**New File #8-B-25-OB**

**Denial of Middle Housing**

**Property Address:** 1214 Callaway St

**TO:** R. Bentley Marlow, Property Owner  
**FROM:** Lindsay Lanois, Principal Planner  
**DATE:** June 27, 2025  
**SUBJECT:** Middle Housing Review – 5-A-25-MH  
**ADDRESS:** 1214 Callaway St (Parcel ID 094F17)

**A101**

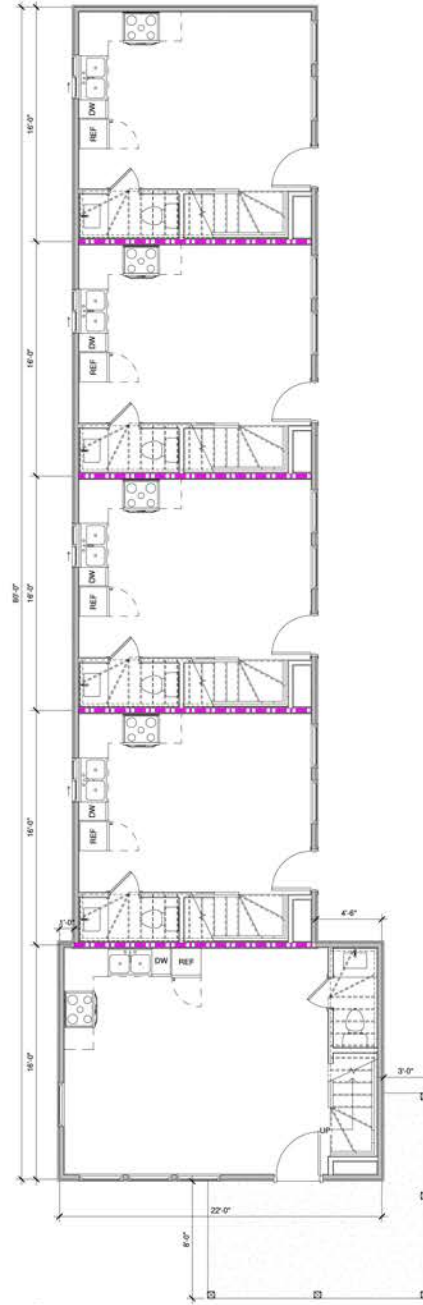
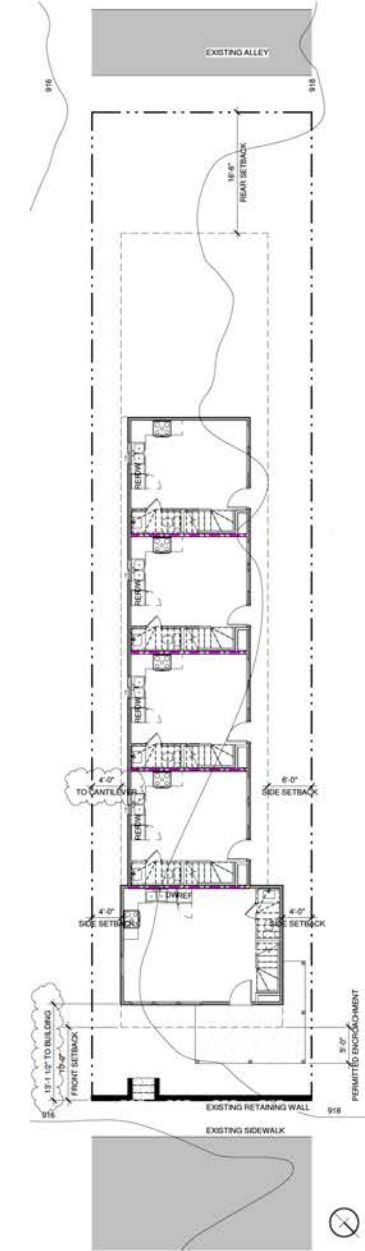
- The building is described as a “multiplex,” which is defined in Article 4.6 as a small-to-medium-sized structure that consists of five to ten units arranged side-by-side and/or stacked, often with a shared entry on the ground floor. The building does not have a shared entry on the ground floor and does not meet the intent of the definition of multiplex.

- The proposed design does not meet the zoning standard in Article 4.6.E.5.c, “townhouses shall not be oriented perpendicular to the street. The narrow side of townhouse units must face the street.”

- The proposed building features four units oriented perpendicular to the street, fronting the side elevation.
- The proposed 2.5-story, 5-unit townhouse does not meet the intent of Middle Housing standards “to promote the development of neighborhood-scale housing forms which are compatible with existing housing in the surrounding area” (Article 4.6). The building is not “similar in footprint, height, and setbacks with the existing neighborhood” (Article 4.6.E.4). This is also stated in Article 4.6.G as “the intent of Article 4.6 is to allow Middle Housing types which are in harmony with the surrounding neighborhood and will not be injurious to it or the public welfare.”

- The building is 2.5 stories tall on a block characterized by 1-story shotgun houses. The building is 80' deep, the maximum building depth for a multiplex, and will be deeper than the context. The side elevations feature massings which cantilever an additional 1' outwards from the building.

- The property is zoned RN-4 within the TDR land use area. The lot frontage on Callaway Street is 30' wide with an alley. The proposed lot does not meet the minimum lot width for a multiplex in Table 4-4 of Article 4.6 (70' with an alley). The application uses Article 17.3.B to allow development of a non-conforming lot of record, which "must meet all applicable dimensional and design requirements of the district in which it is located," with the exception of lot width. The application proposes the largest form of Middle Housing.

- The application requests an administrative variation, reducing the required 5' interior side setback to 4'.

4 LEFT ELEVATION  
 A201 3/16" = 1'-0"

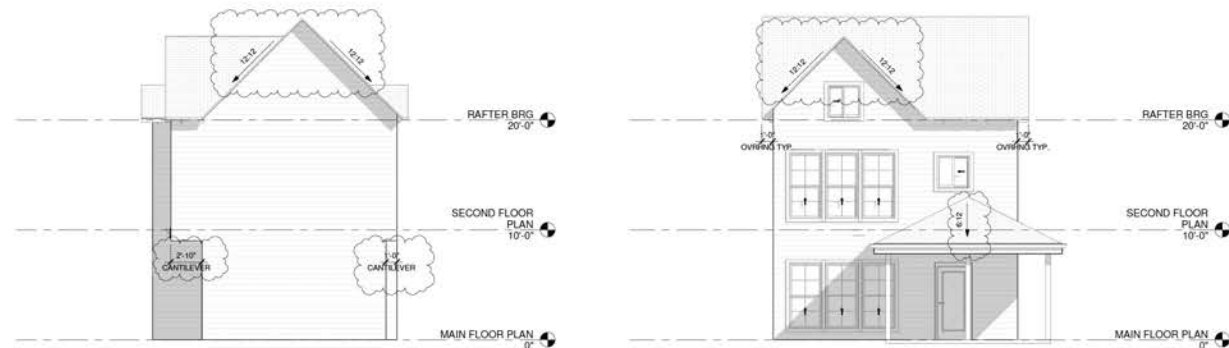
- Article 4.6.E.4.b requires "recesses or projections in the building wall of any front or side elevation that exceeds a length of 50'," which shall be at least 2' wide. The proposed projections take the form of cantilevered massings which do not extend to the foundation. The first story contains no recesses or projections in the building wall.
